Administrative Review

Subject: Case #2022-05: Nicholas Calvetti and Amherst Label Realty, LLC. for the property located

Milford Tax Map 15, Lot 15, 15 Westchester Drive - Special Exception Application Wetland

Buffer Encroachment

SP-3

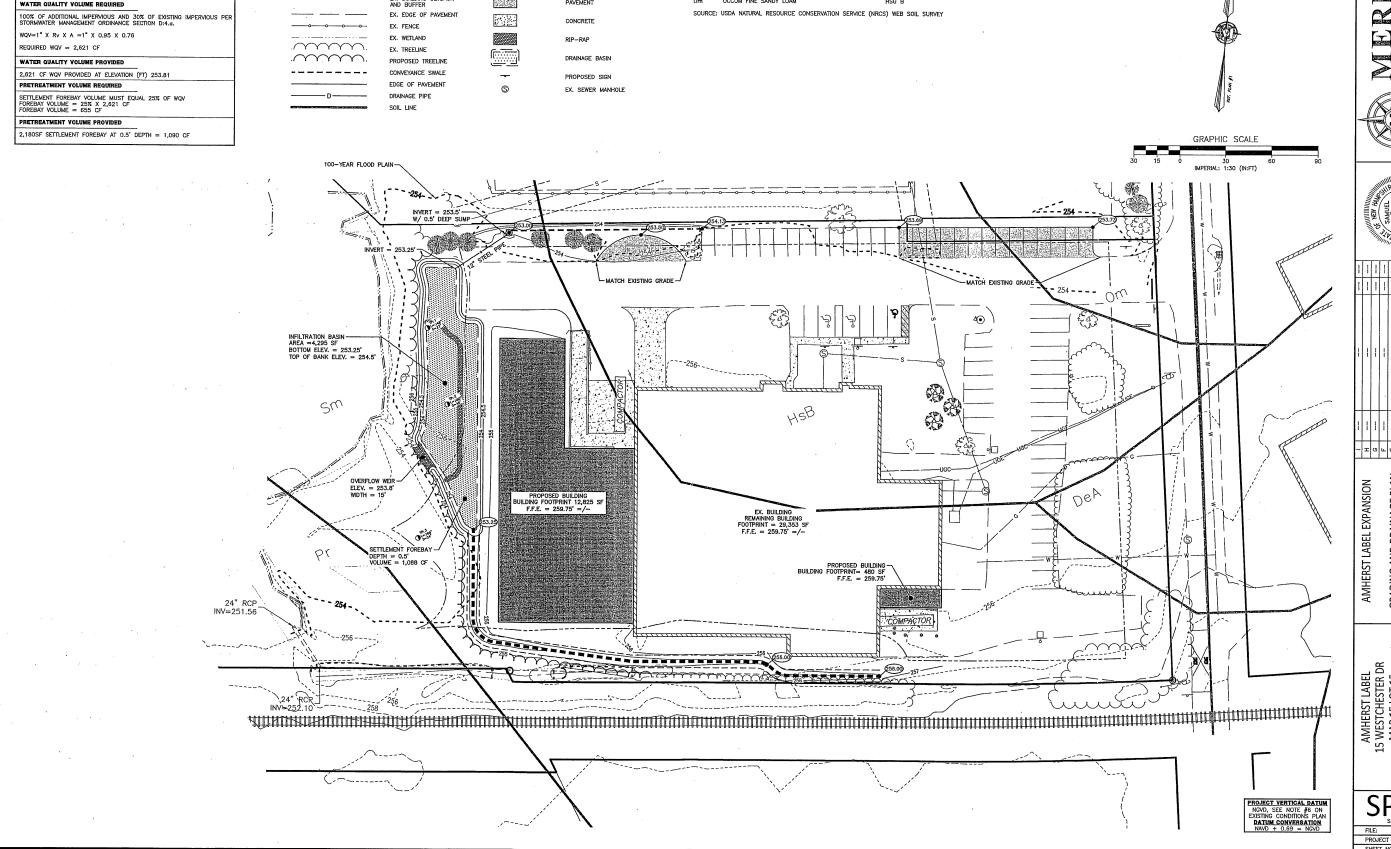
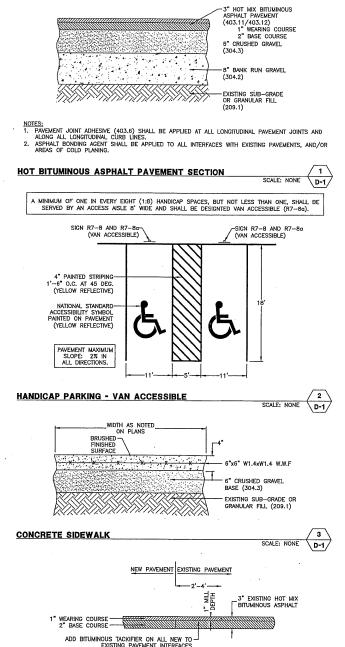
The applicant is before the Board of Adjustment seeking a SPECIAL EXCEPTION from the Milford Zoning Ordinance, Article VI, Section 6.02.6 to disturb approximately 7,410 square feet of wetland buffer area to allow the installation of a infiltration basin and related site improvements in the Industrial 'I' Zoning District. In reviewing the files for this property, I offer the following comments:

- 2. Amherst Label proposes to expand their existing facilities with a net building increase of 9,900 sf+/-. The additional site improvements include the installation of an infiltration basin within the delineated 50 foot delineated wetland buffer associated with Tucker Brook to provide the required water quality and attenuation

for the proposed redevelopment. To install the infiltration basin for treatment and discharge rate control of the runoff, the 50' wetland buffer associated with Tucker Brook will be impacted by approximately 4,690 sf.

In addition to the infiltration basin, a collection swale will be constructed within the 25 foot wetland buffer of the existing wetland/ditch along the southern portion of the property. The proposal will result in an additional wetland buffer disturbance of approximately 2,720 square feet.

- 6. As part the applicant's presentation, they should be prepared to discuss the alternatives considered for the layout of the building addition, stormwater design, and impact to the functionality of the wetland and associated wetland buffer.

- 1. The need for the impact.
 - The MCC would like a smaller warehouse to reduce the impact on the buffer.
 - The applicant refers to the current condition of the site which has no stormwater management systems in place. Their argument is that the stormwater retention basin will add to the functionality of the buffer and will be better than what is currently on the site. The preliminary design presented to the MCC will be a manmade structure that will not be able to provide the services, beyond water treatment, that the current buffer provides to the habitat surrounding the Amherst Label facility.
- 2. The impact on plants, fish, and wildlife.

However, the buffer provides more services than just water treatment. These services aren't adequately replaced with a manmade structure as designed. Incorporating some of the existing trees and shrubs which are treating the stormwater currently, would mitigate some of the impacts of this proposed buffer activity. There would be a noticeable impact if all the landowners replaced their natural buffer with a vegetated swale along Tucker Brook.
- 6. The impact of the proposed project on the values and functions of the total wetland or wetland complex.
 Per #2, Wetland Buffers provide services in addition to simple filtration and regulation of water flow, notably habitat features required by characteristic wetland flora and fauna. The planned encroachment would severely degrade the latter.

The Commission does not support the request for a Special Exception as presented in the current plan and requests the developer revise the plan to accommodate the comments made here with a view to minimizing its impact, or preferably eliminating the need altogether for a Special Exception.
